T.G. MILLER P.C.

December 12, 2014

Re: Cayuga Farms, Preliminary Plan

DATE: OCT 30, 2014
 SCALE: 1"=60'
 DRAWN: SDG
 JOB: 10-07
 SHEET: ST-10

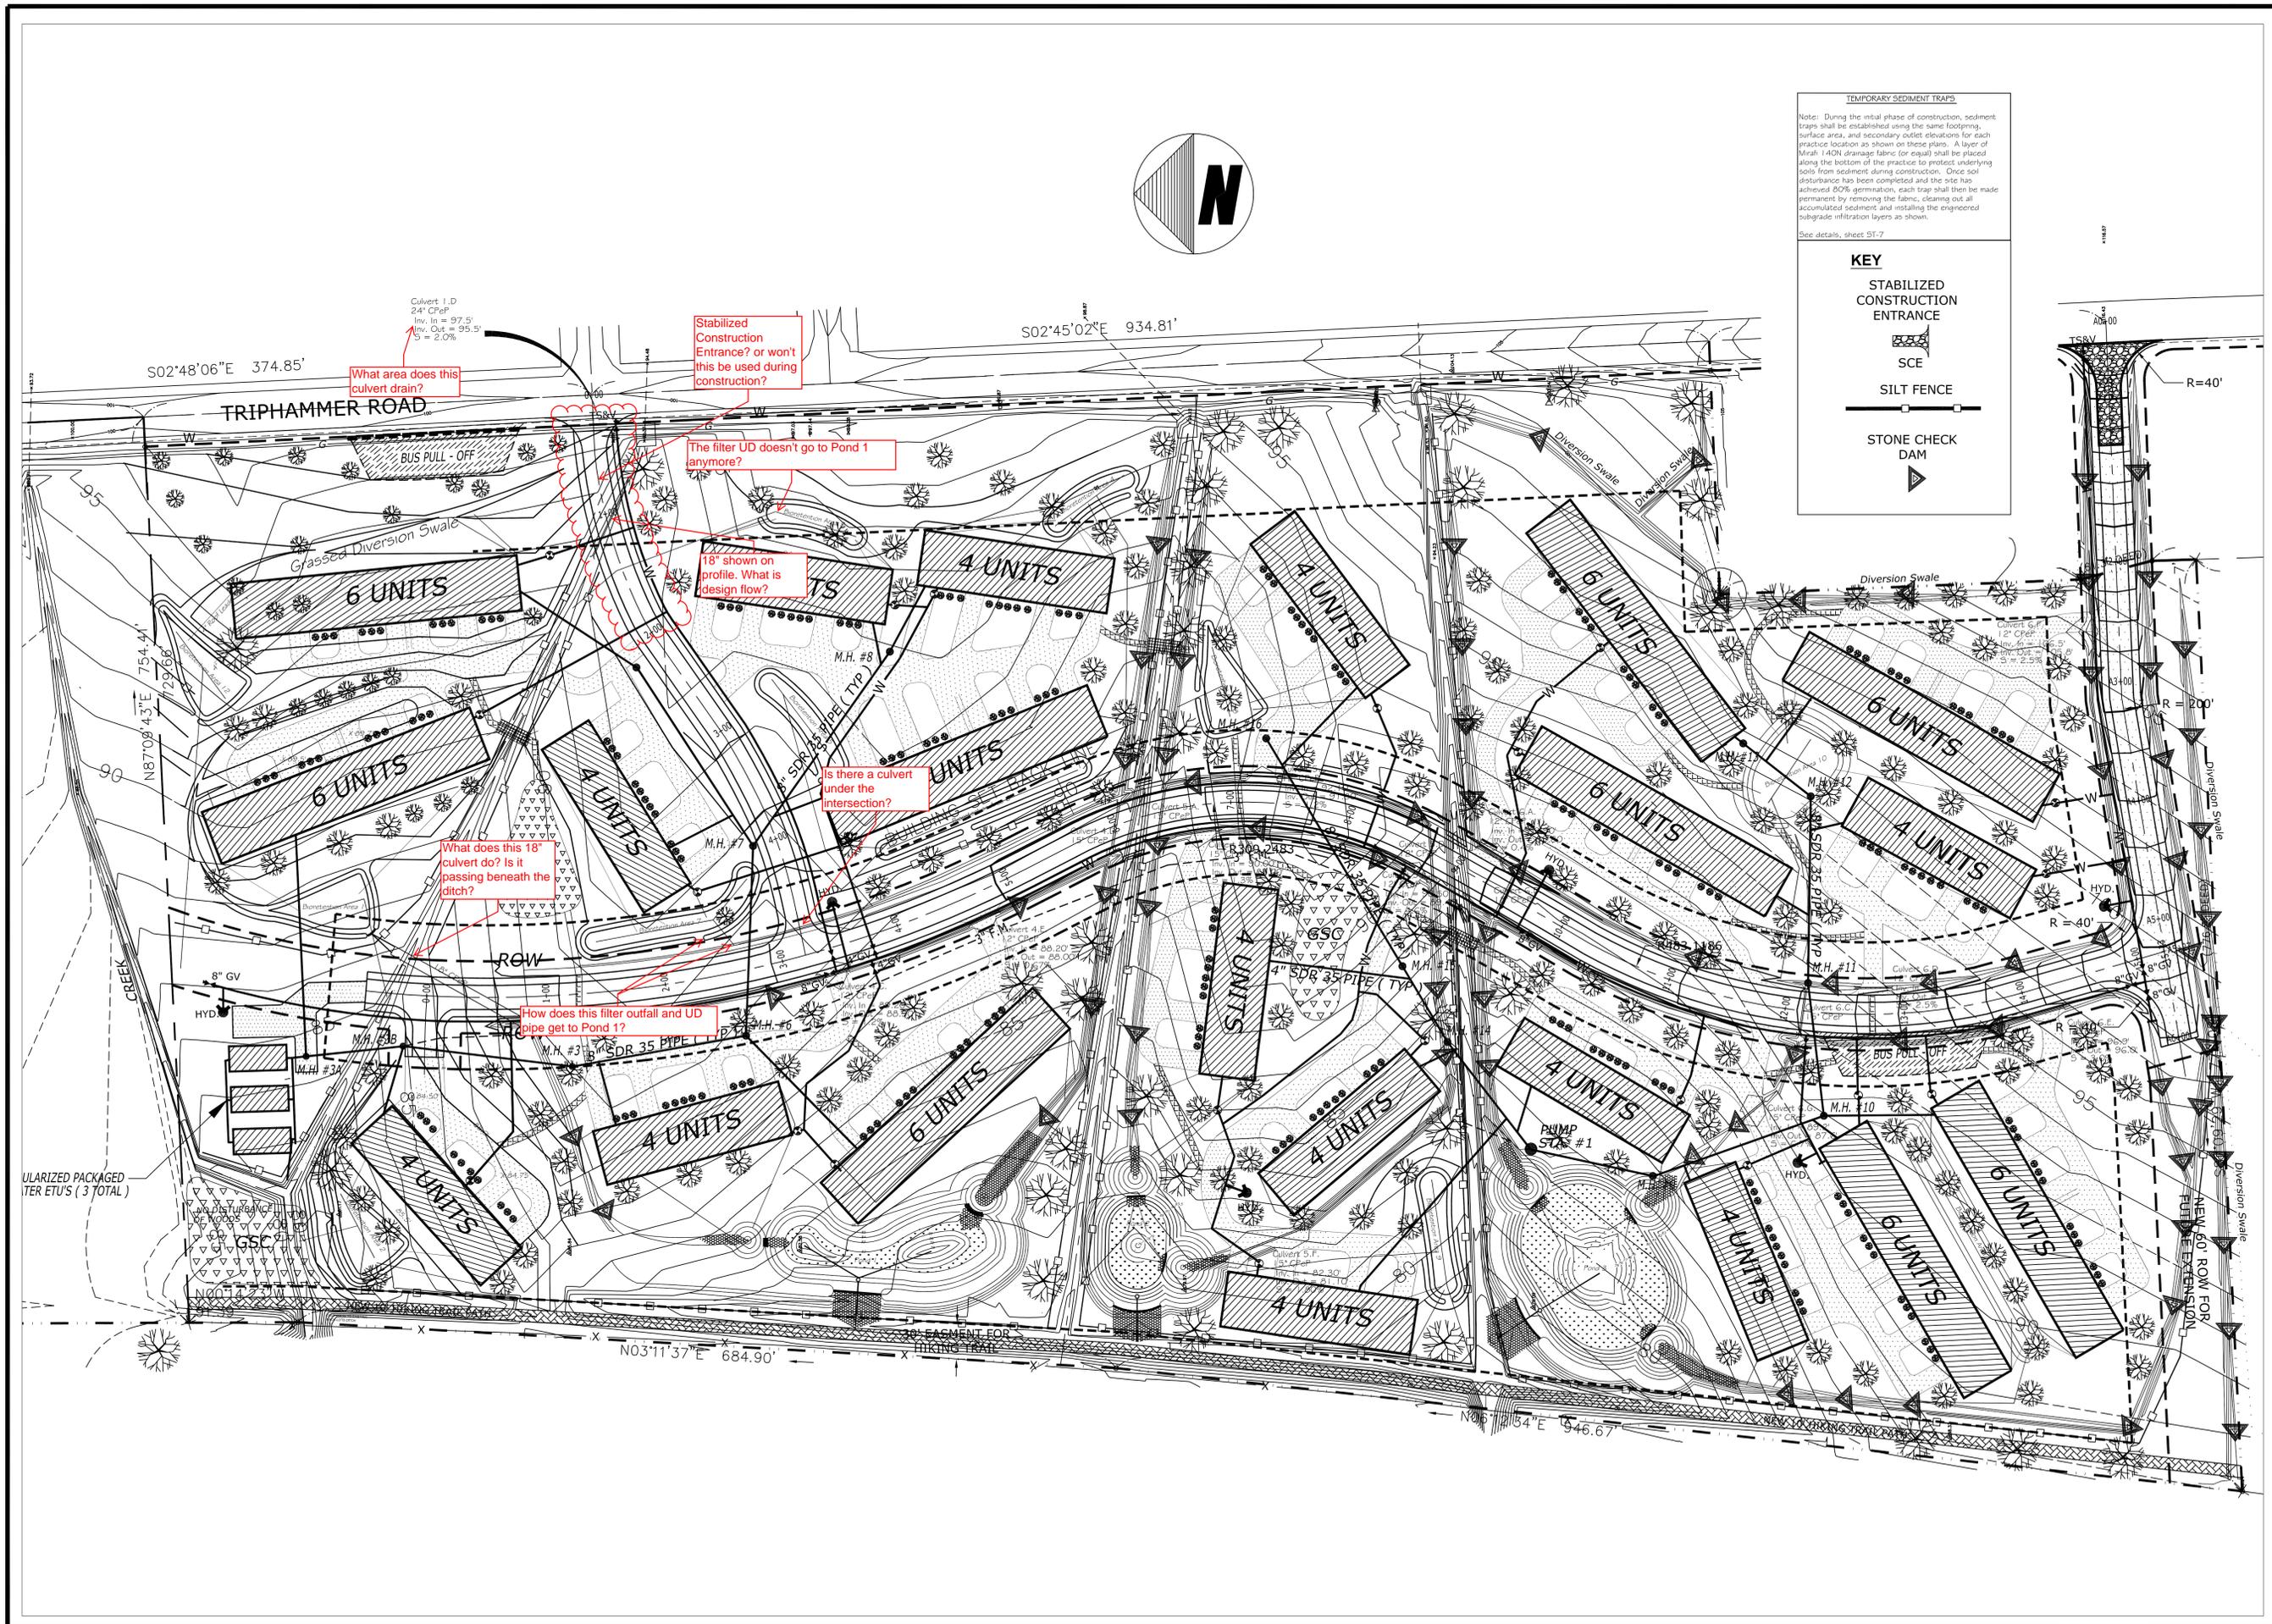
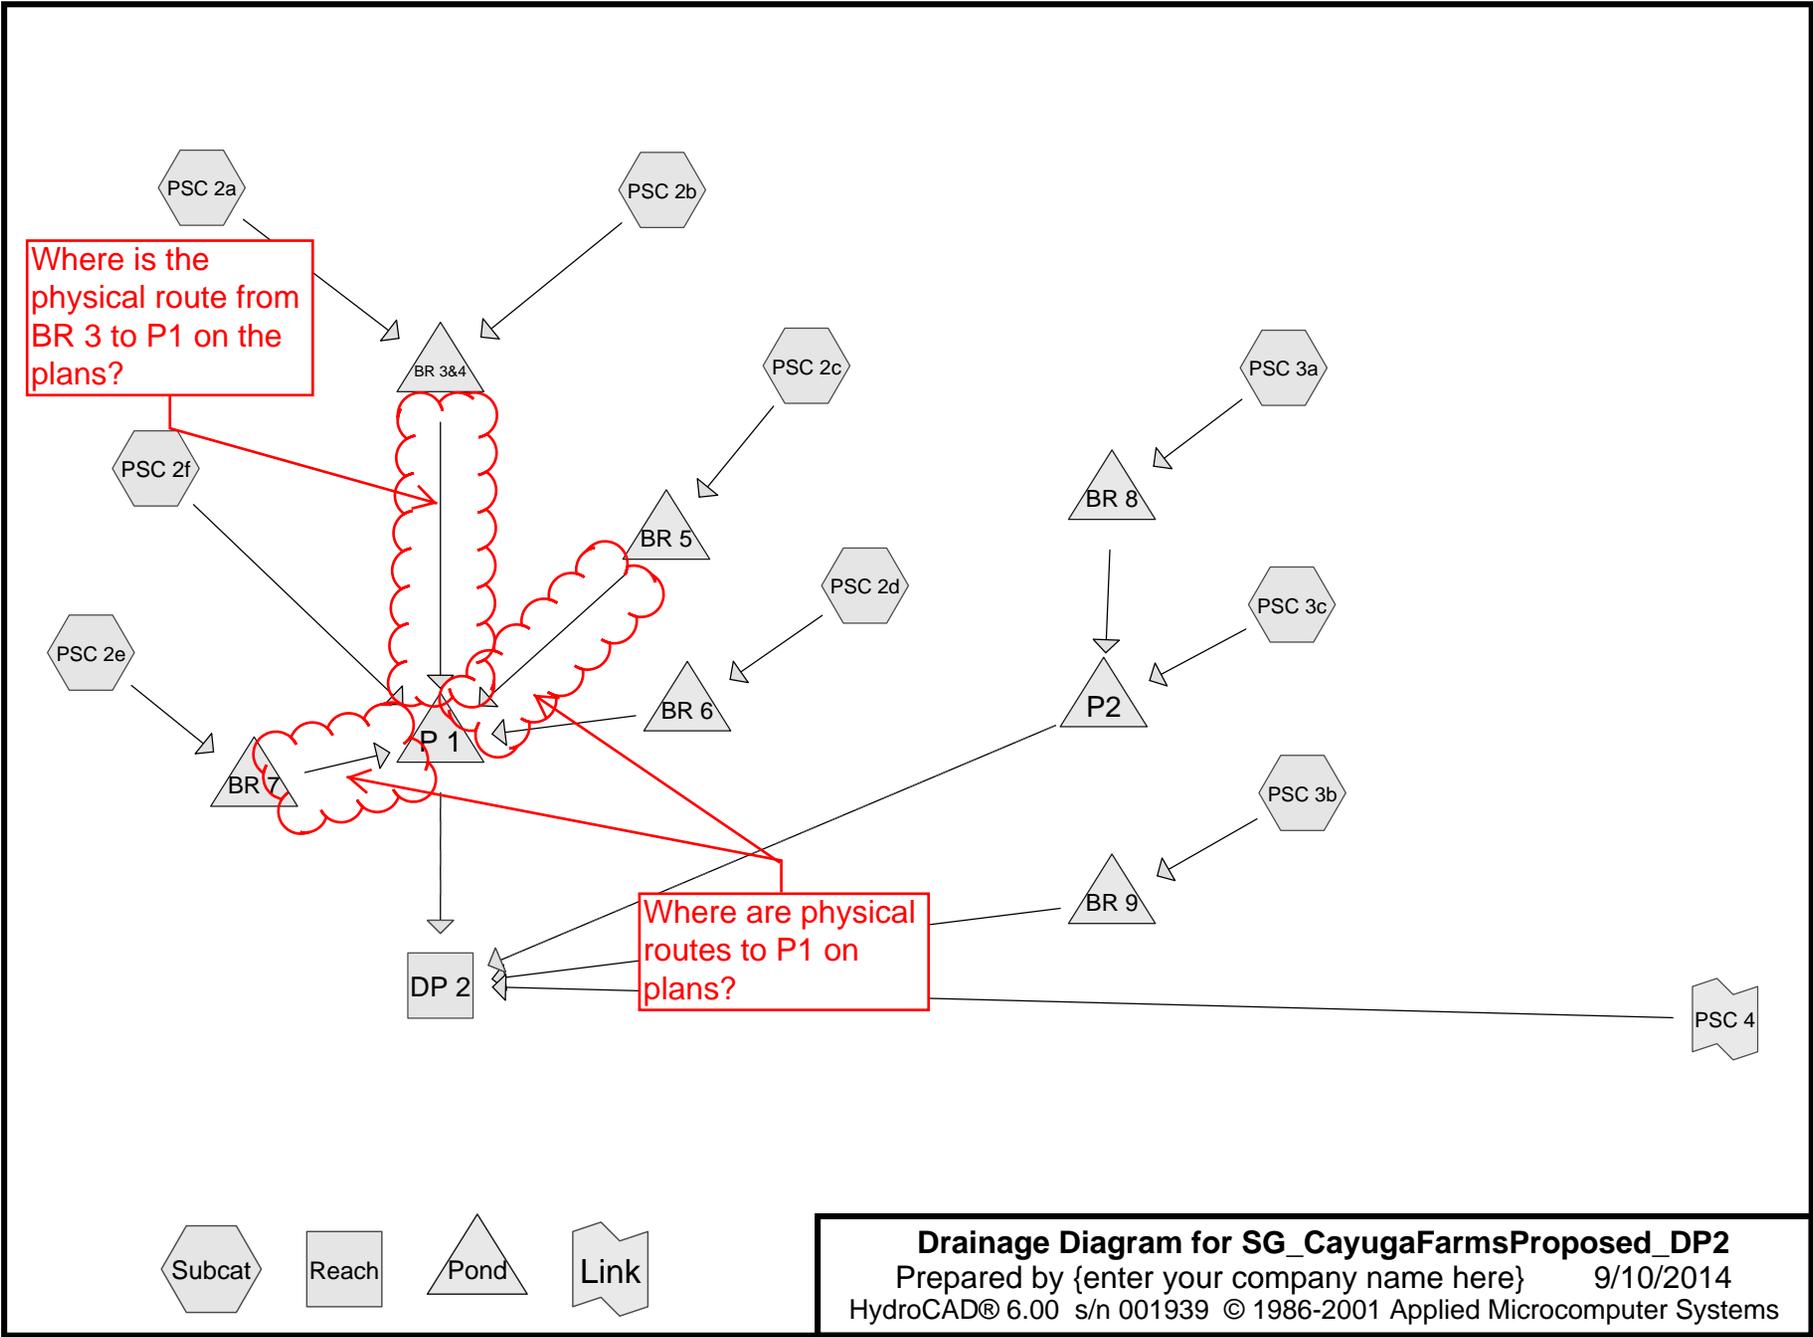
1. I've marked up several pages from the SWPPP and Sheet ST-10 with questions that can be addressed by Mr. Buhl in a subsequent plan submission.
2. I still contend the Town be provided some technical evidence that the capacity of the existing drainage channels extending across the property is sufficient to avoid flooding of the adjacent buildings. I believe this is a reasonable request and trust that the project engineers/architects share a similar interest. Specifically, what is the capacity of the existing drainage channels and under what rainfall events might these channels overflow? The road profiles indicate 36-inch CMP at the channel crossings. How have these been sized?
